Re: WT Docket No. 01-309
Section 68.4(a) of the Commission's Rules Governing Hearing Aid
Compatible Telephones

**ATIS Industry Solutions Program #4 –
Hearing Aid Compatibility
(AISP.4-HAC)**

**Comments in Response to
TCB Training Slides**

AISP.4-HAC – FCC OET Meeting
September 25, 2006

WG-4 Rationale - Slide 32, Vocoder Modes

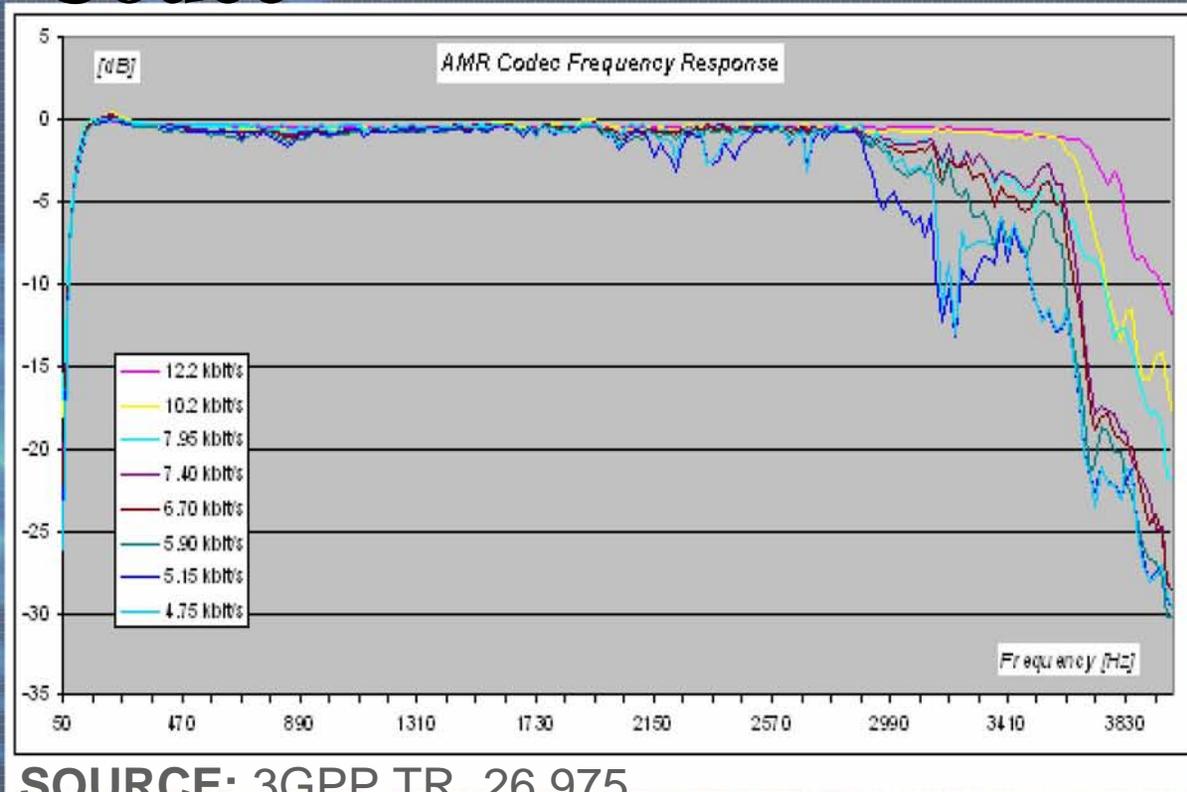
- Most vocoder modes will not pass HAC T-Coil frequency response requirements.
- Many vocoders are not intelligible (used to hold a call up during periods of silence, conserving bandwidth). An example is CDMA 1/8 rate.
- GSM, iDEN, and UMTS vocoder rates have no impact on HA interference. GSM (EFR), utilizes best speech quality
- Vocoder voice quality degradation is the same for all. HAC devices should meet same requirement.

- Significant time is added to test time when requiring all vocoders.
- AISP.4-HAC Agreement
 - **“When performing C63.19 sections 6.3 & 6.4, the same vocoder rate that is used in section 4.4.1.2.2. should be used during the measurement.”**

- Adopt the AISP.4-HAC agreement reached regarding evaluation and testing vocoder modes for hearing aid compatibility.
